FRONT STEP MOLDING FALLEN OFF AFTER DRIVING ON SNOW AND ICE

Bulletin No.: 09-045/17

2016-2018 CX-3

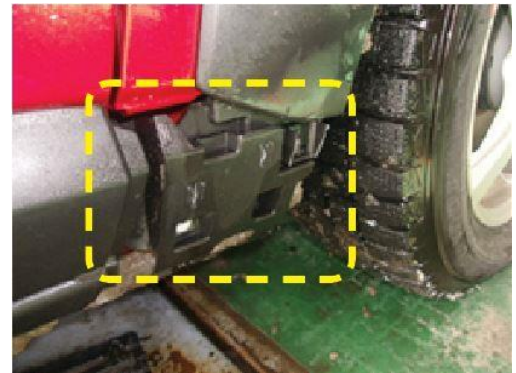
Some customers driving on snow and ice may find the front step molding fallen off. This may be caused by snow and ice accumulated under the molding when contacting a snow pile. The front step molding structure may not be strong enough to hold under certain conditions.

1. Verify customer concern.
2. Replace the front step molding on the affected side. Refer to MGSS online Workshop Manual SIDE STEP MOLDING REMOVAL and SIDE STEP MOLDING INSTALLATION.
3. Verify repair.

Parts Number	Description	Qty.	Notes
D10E-51-PJ0C	MOULD(R),STEP-FRT	1	Only replace the front step molding on the affected side
D10E-51-PP0C	MOULD(L),STEP-FRT	1
